FHWA REGION NO.	STATE	PROJECT NO.	YEAR	SHEET NO.	TOTAL SHEETS
7	KANSAS	54-87 K-6657-01	2002	12	1122

Revisions		By	Date
CITY OF WICHITA			
FOUNDATION TREATMENT & COMPACTION OF EARTHWORK			
SEDGWICK COUNTY			
Professional Engineering Consultants, P.A. 303 S. TOPEKA • WICHITA, KANSAS 67202 316-262-2691 • FAX 316-262-3003			
Designed by	WDH	Checked by	WDH
Drawn by	JGP	Date	Apr 11, 2002
		Job No.	97362

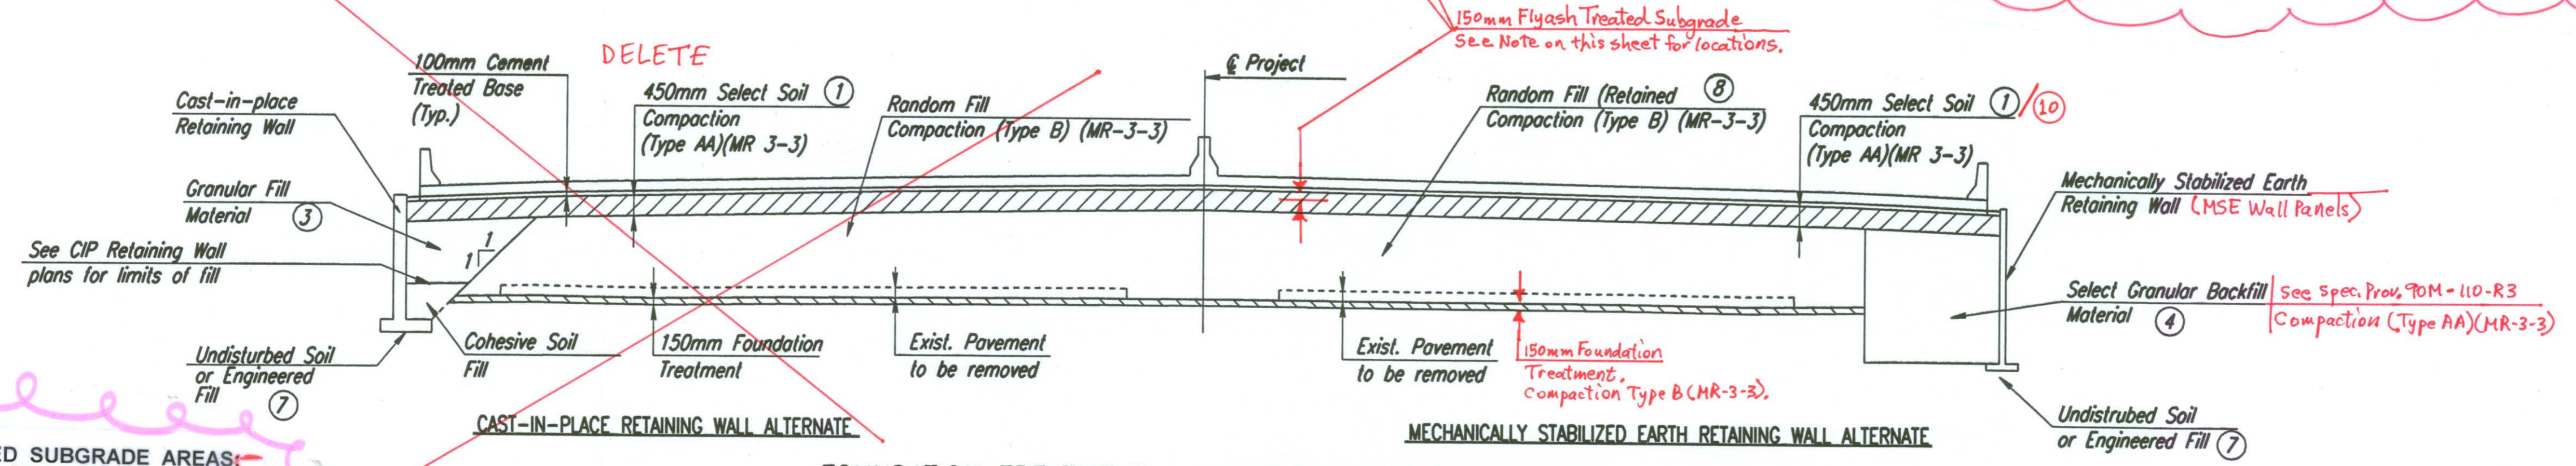
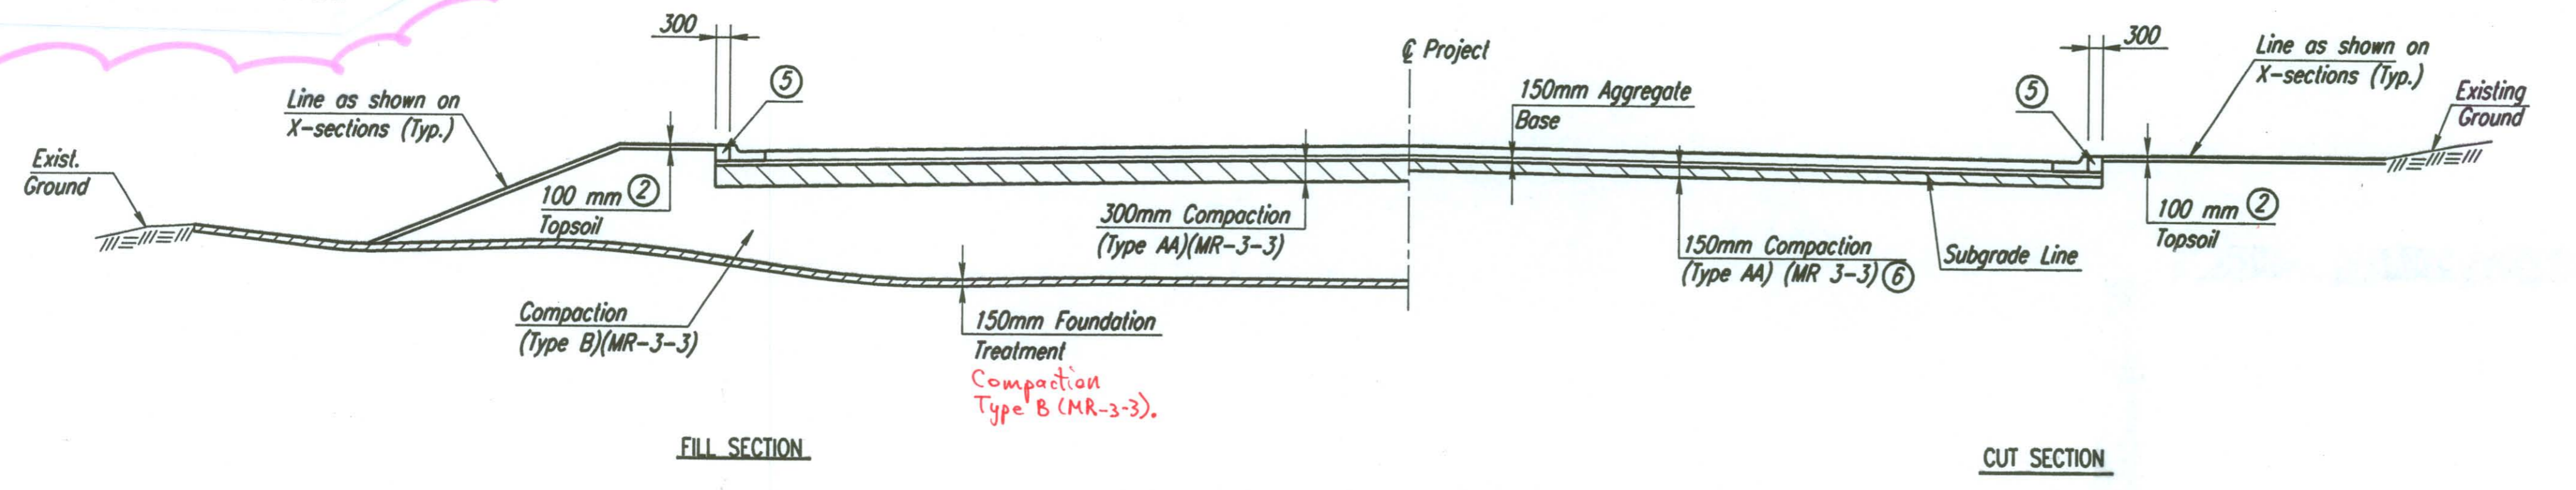
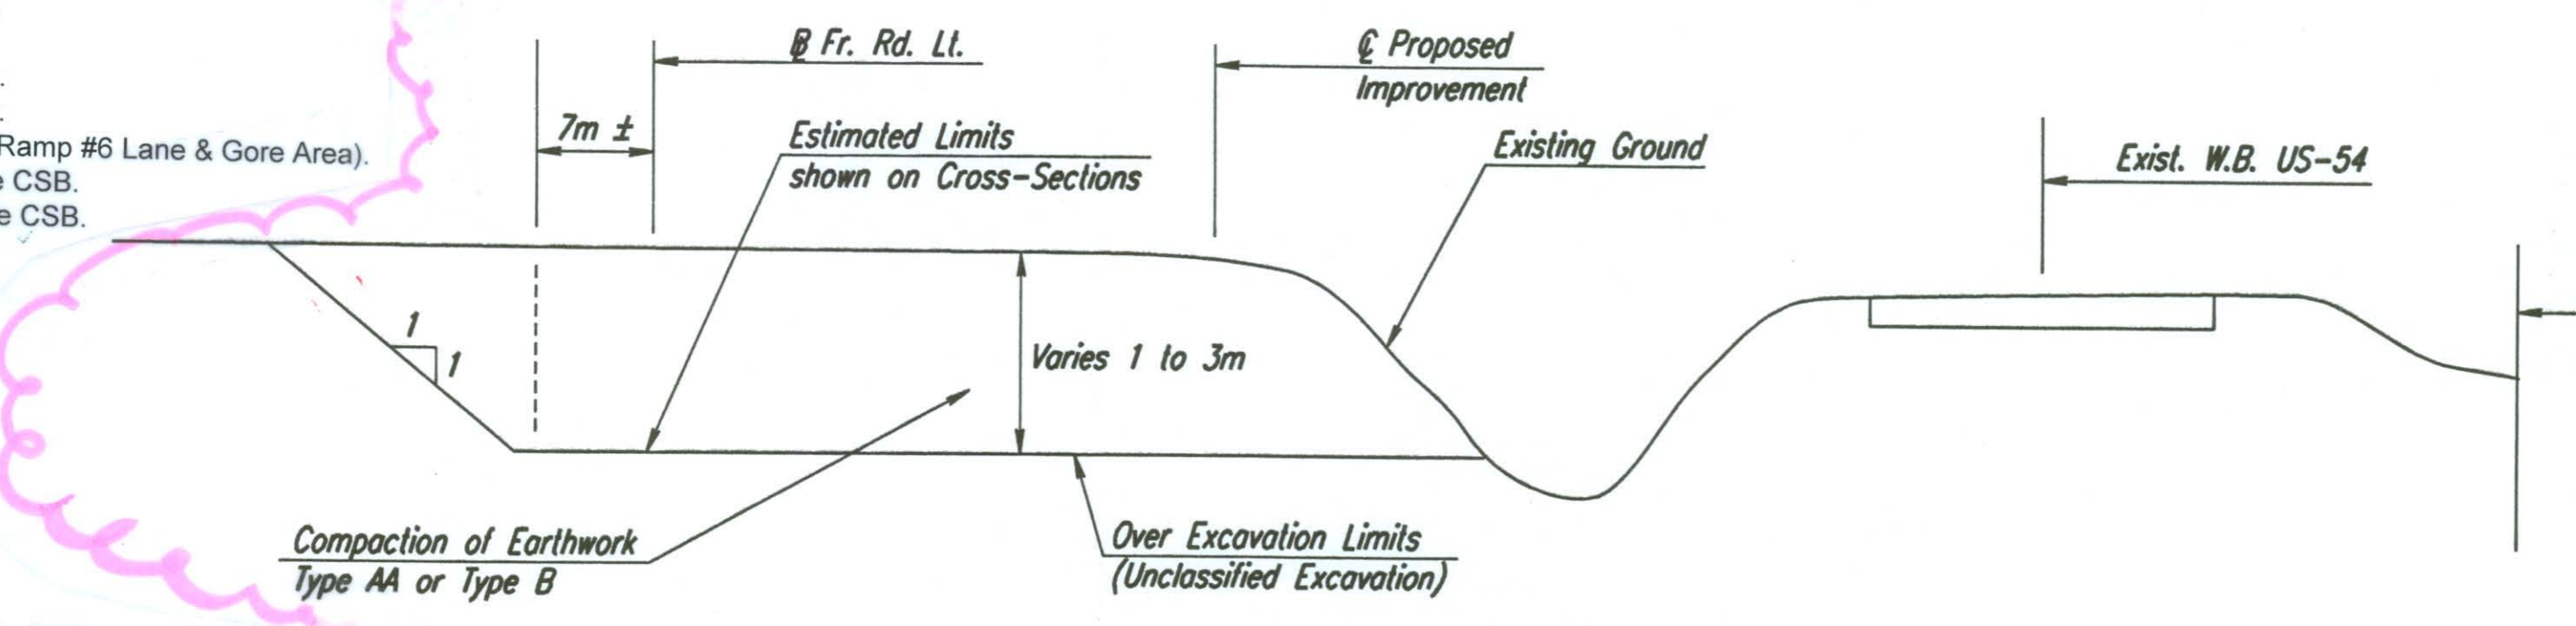
15. Add the following notes to Sheet No. 12. **ADDENDUM #2:**
 Add to Note 1. The material provided for the Select Soil in the top 450mm may be lime or fly ash stabilized, at the Contractor option, in order to meet the specified requirements. This work shall be performed off-site in accordance with KDOT specifications. Lime and/or fly ash stabilization will not be measured or paid for separately, should the contractor decide to use this method, but shall be Subsidiary to the contract unit price bid for "Embankment (Contractor Furnished)".

15. Add the following notes to Sheet No. 12. **ADDENDUM #2:**
 Add to Note 8. On-site Common excavation may be placed in the lower 4 meters of the random fill embankment area for the MSE retaining wall alternate. The MSE wall supplier shall take into consideration the use of this material, if done, in the wall system design.
